RE: **STAFF SUMMARY REPORT**
LARGE-SCALE DEVELOPMENT PLANS – HEDBERG ALLERGY BUILDING ADDITION

PROJECT NAME:	Hedberg Allergy Building Addition
ADDRESS/LOCATION:	700 S 52 nd Street
PROPOSED USE:	Medical, Dental, and Health Practitioner Office
CURRENT ZONING:	R-O (Residential Office) and C-2 (Highway Commercial)
CGM GROWTH DESIGNATION:	Commerce Corridor
APPLICANT/REPRESENTATIVE:	Jorgensen and Associates
PROJECT OWNER/DEVELOPER:	Hedberg Allergy & Asthma Center – Michelle Hedberg
PROPERTY OWNER:	Hedberg Allergy & Asthma Center – Michelle Hedberg
NATURE OF REQUEST:	Approval of Large-Scale Development Plans
AUTHORITY:	Chapter 14, Article III, Rogers Code of Ordinances

LARGE SCALE DEVELOPMENT PLAN FOR: HEDBERG ALLERGY - BUILDING ADDITION

SHEET TITLE
LARGE SCALE DEVELOPMENT PLAN

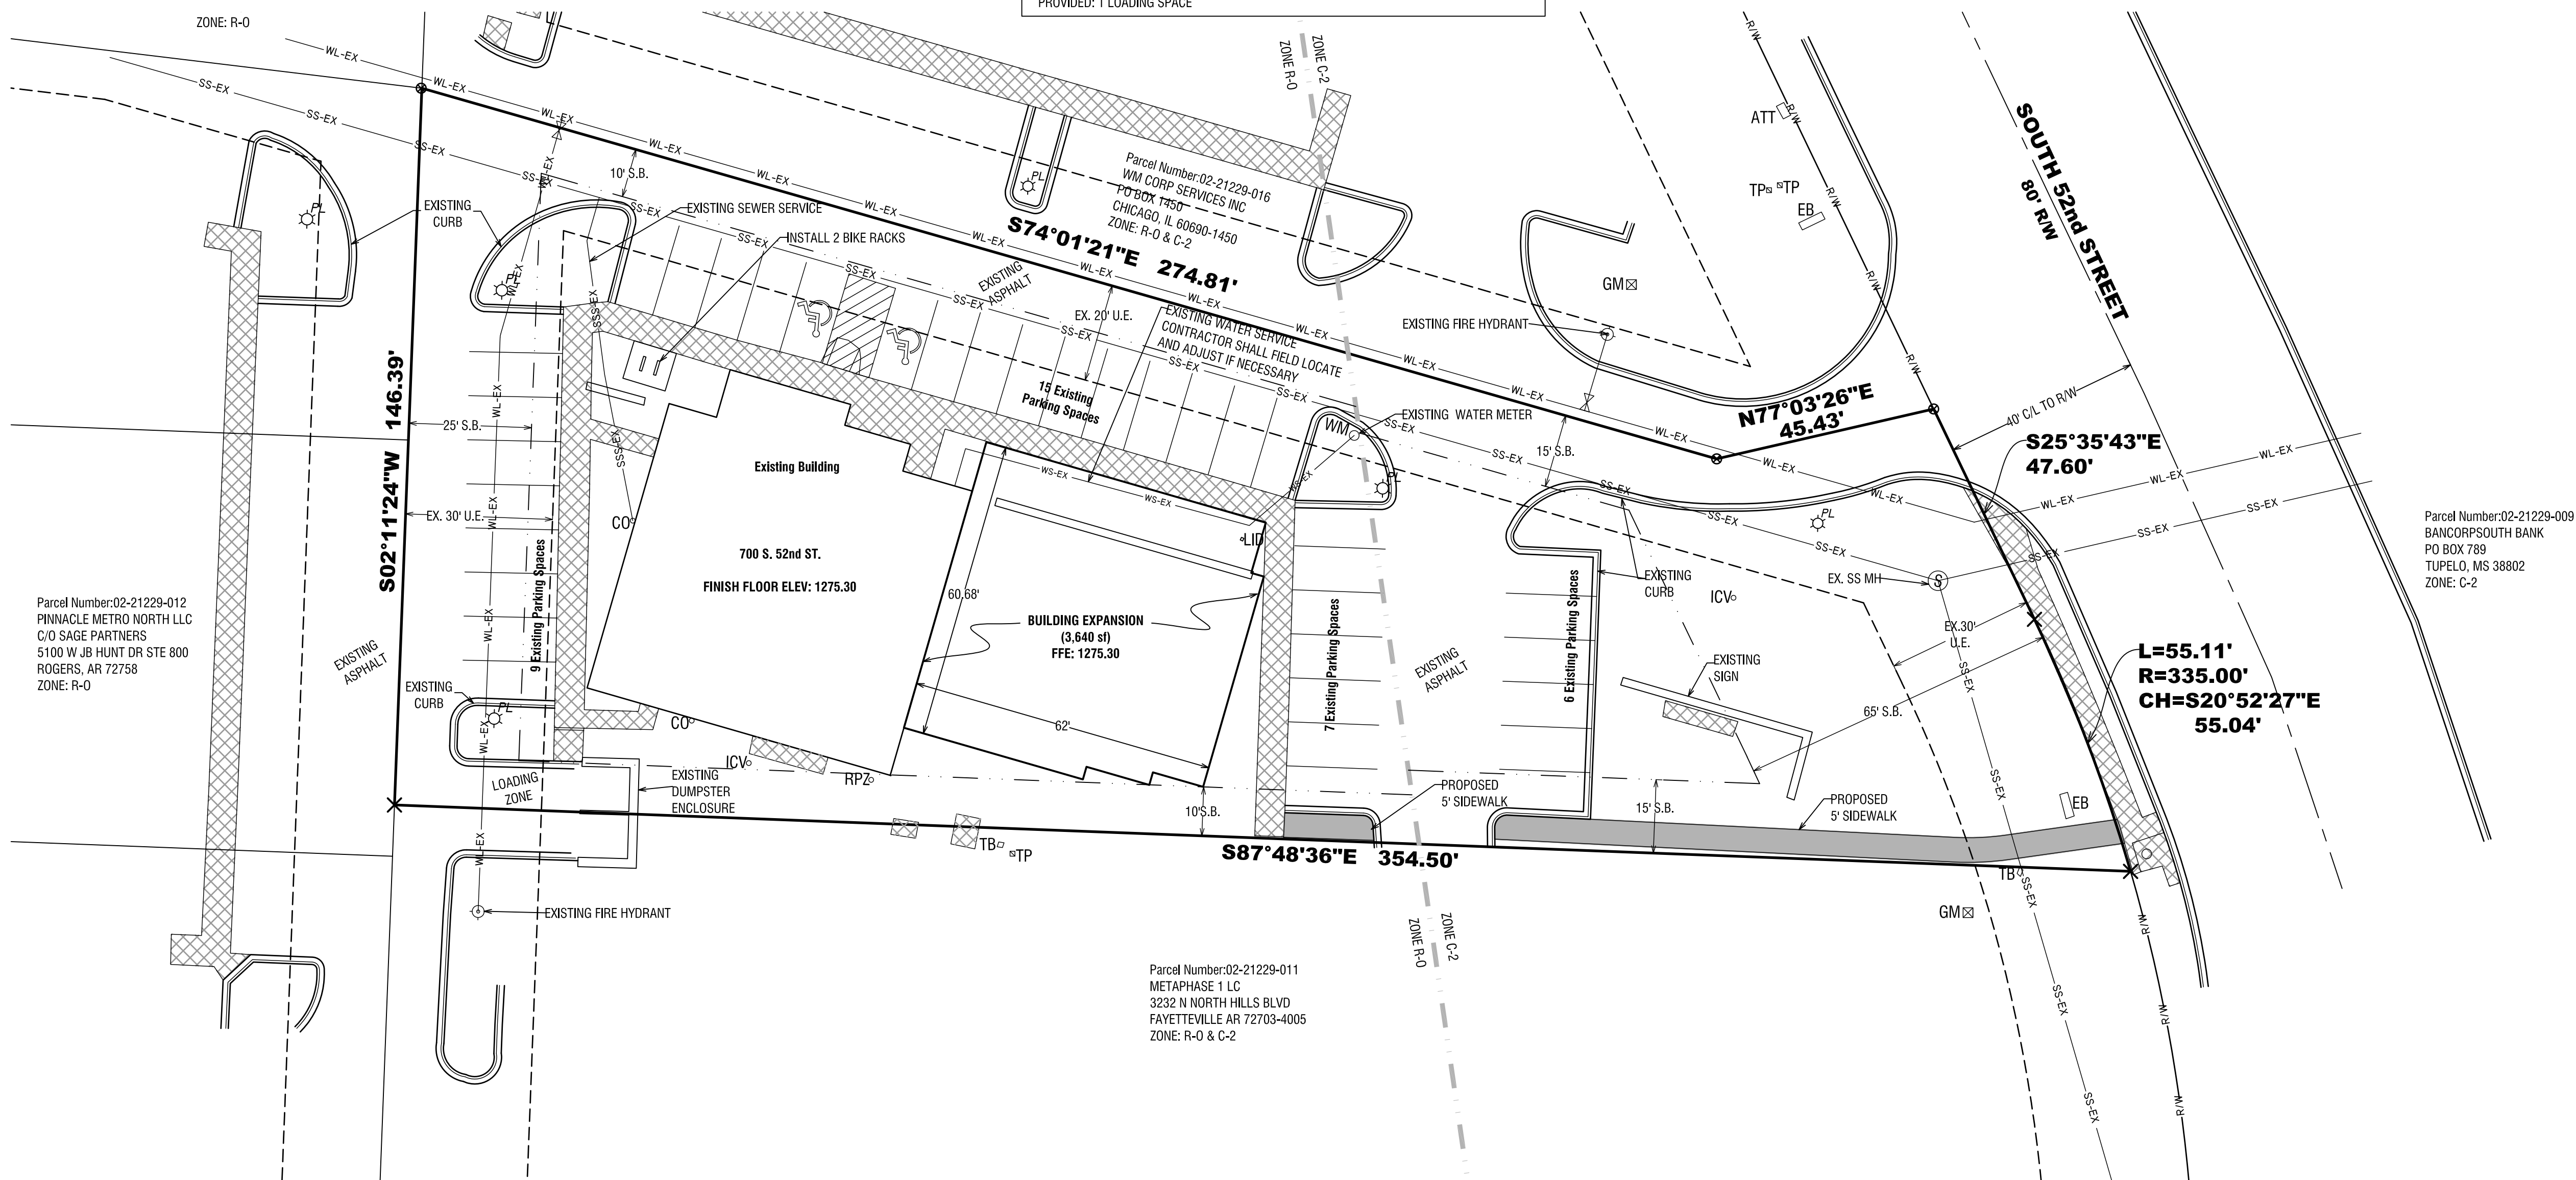
The pavement along S 52nd Street is in good condition. The right-of-way is substandard and does not match the Typical Street Section. The applicant requests a **WAIVER** from Sec. 14-256 from requiring right-of-way dedication and street improvements.

The existing S 52nd Street right-of-way is 80ft on center, and an additional 10ft of right-of-way dedication would be required unless waived, as requested, along this property.

The existing sidewalk along S 52nd Street is 5ft and does not meet the requirements per the Typical Street Section. A 10 foot wide sidepath would be required unless waived, as requested, along this property.

Approve WAIVER from Sec. 14-256. The existing 5ft sidewalk and existing right-of-way aligns with developments along this path. There are existing utilities that would require relocation. There are mature trees that would be required to be removed in order to meet this requirement. When determining the amount of and necessity of a dedication or upgrade the City shall consider whether the upgrade or dedication has a reasonable nexus to the legitimate interest of the City and whether the details of the upgrade or dedication are reasonably proportional to the impacts of the project as required by state and federal law [per Sec 14-580(4)d].

Please accept this request from Hedberg Allergy Clinic for a waiver from the Code of Ordinances for the City of Rogers, Arkansas, Section 14-256 regarding right-of-way dedication and sidewalk improvements along S. 52nd Street. The development code requires an additional 10' of right-of-way dedication and construction of a 10' wide sidewalk with 6' greenspace, and street trees planted in the greenspace. The property currently has a 5' sidewalk along S. 52nd Street, which matches with the surrounding properties on S. 52nd Street that also have 5' sidewalks. The developer feels that the removal of the existing sidewalk and construction of a 10' sidewalk along the property's frontage at this point will create a situation that doesn't conform with the surrounding properties. There are also established 6" maple trees along the back side of the sidewalk that would have to be removed, along with an electrical box that would have to be relocated. The developer is asking for a waiver from these requirements at this time, but is willing to dedicate right-of-way in the future if improvements are made to S. 52nd Street all at once.

SHEET TITLE
LANDSCAPE PLAN

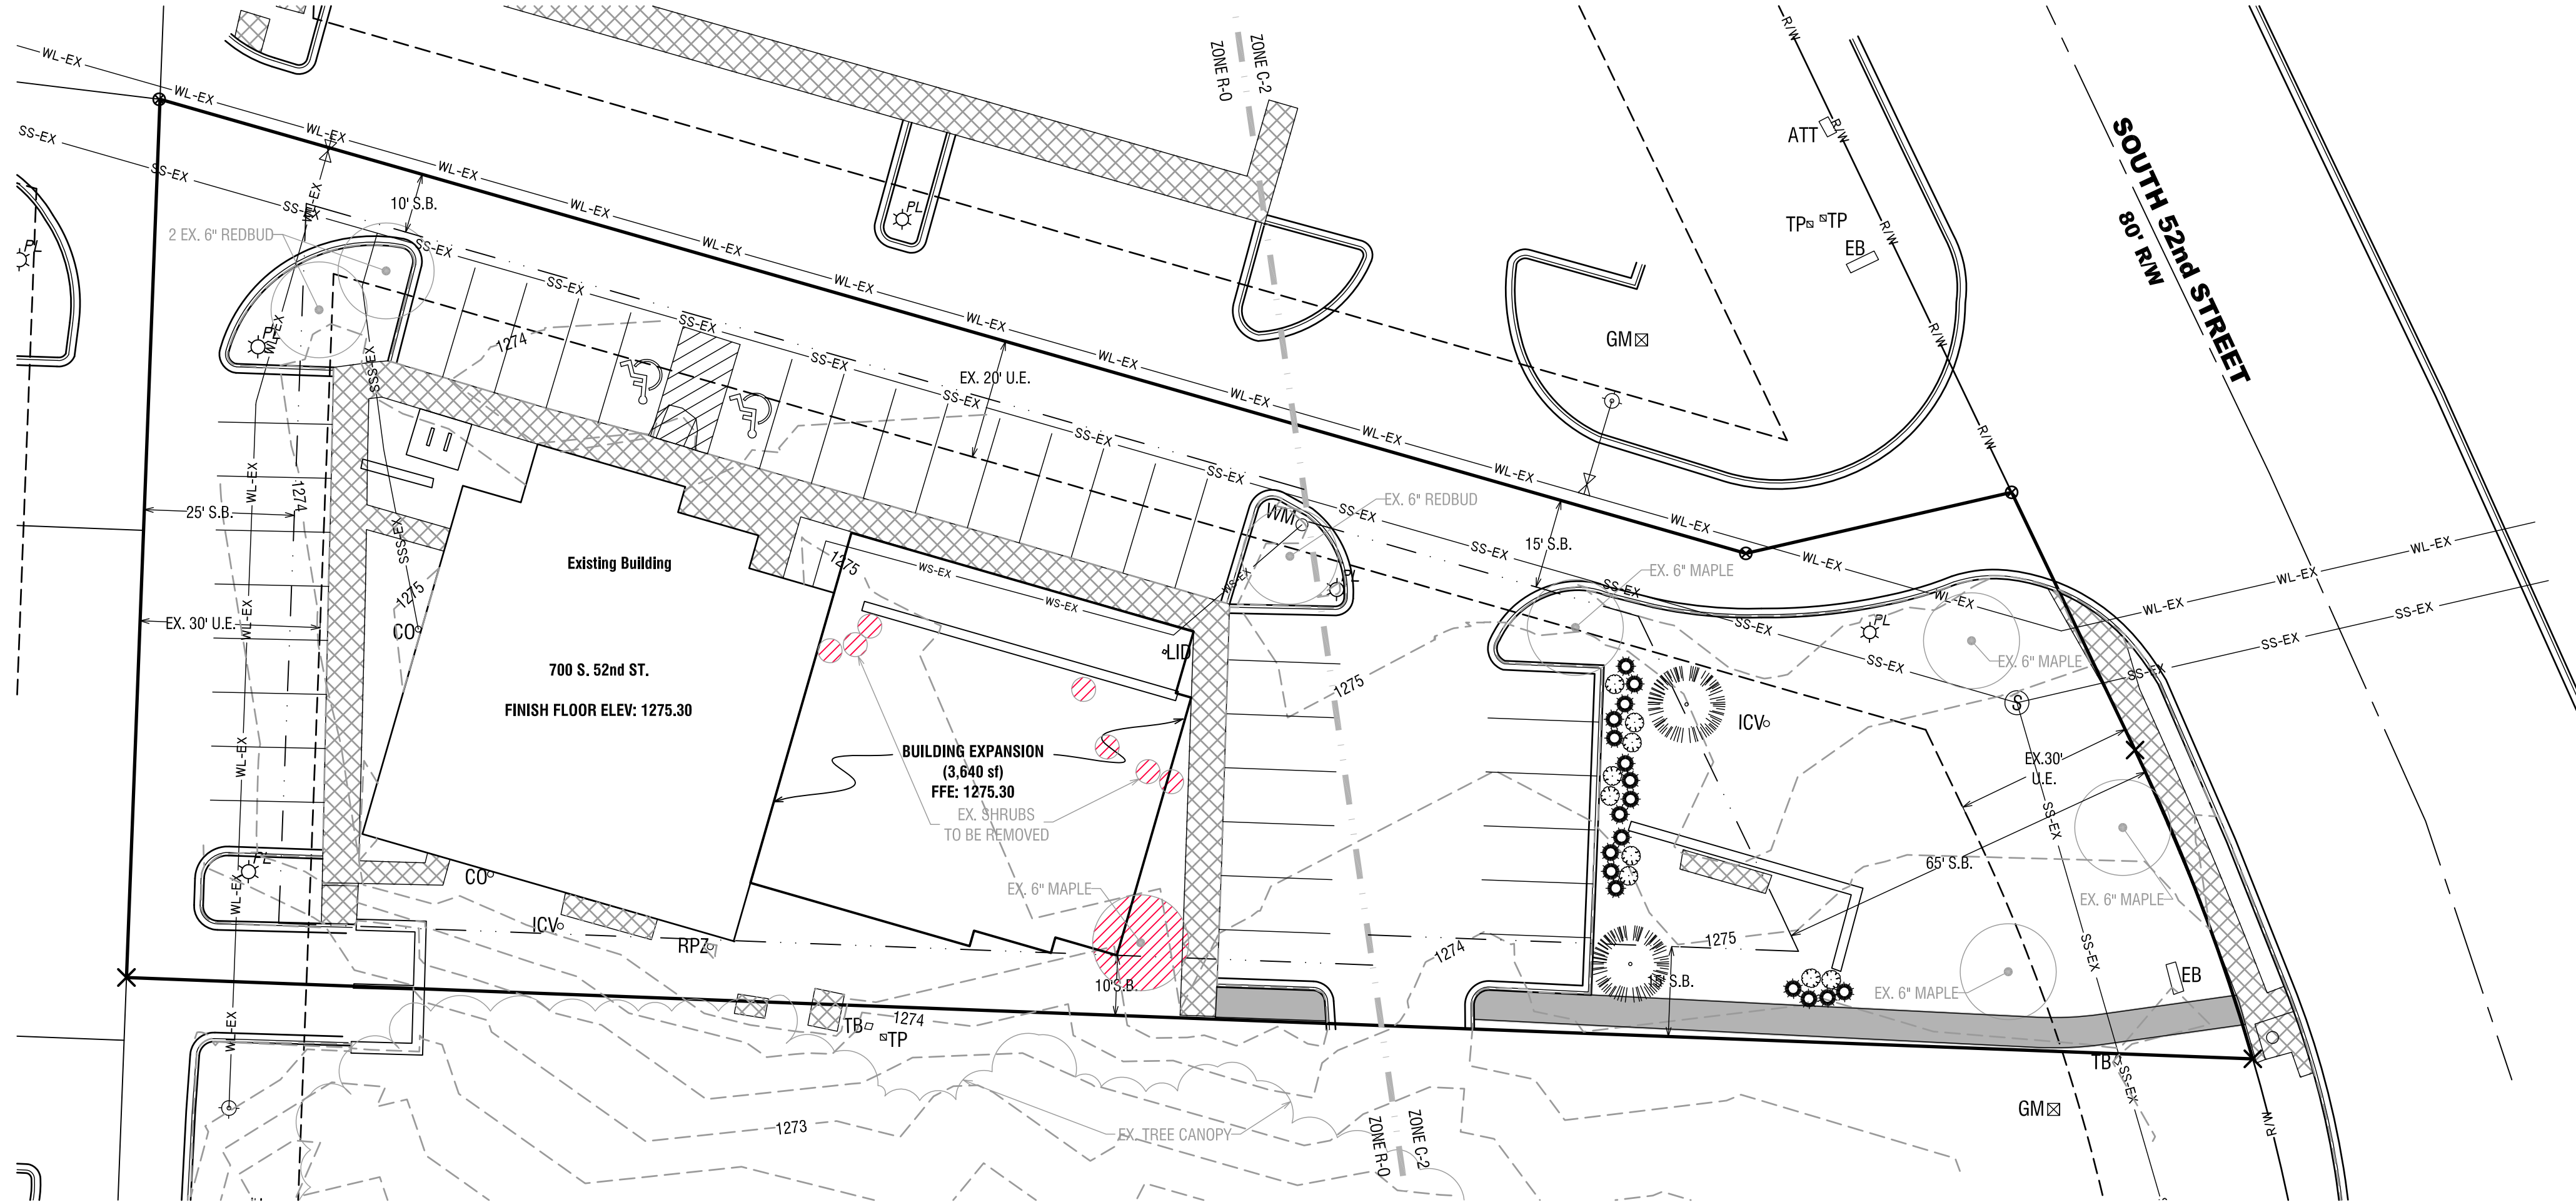
The applicant requests a **WAIVER** from Sec. 14-256(14)(D) for the requirement that no more than 25% of the total number of trees may be ornamental. All other landscaping requirements have been met.

- a) Approve **WAIVER** from Sec. 14-256(14)(D) for the requirement that no more than 25% of the total number of trees may be ornamental. This is an infill development project on a site that has existing landscaping trees, 3 of which are ornamental. Those existing trees bring the total percentage of ornamental trees on site to 33%. The applicant is not adding any additional ornamental trees and they are meeting all other landscaping requirements. Staff recommends approval of this waiver due to the existing trees.

The developer would also like to request a waiver from Section 14-256 (14)(d), which states that no more than 25 percent of the total number of trees may be ornamental trees. The proposed development includes 7 existing trees that shall be preserved, as well as 2 newly proposed trees, for a total of 9 trees total. Of the existing trees, 3 are Redbuds, which are classified as ornamental. This will create a situation where 33% of the trees are ornamental. The developer is asking for a waiver from this requirement, due to the existing Redbuds being well established trees in good condition.
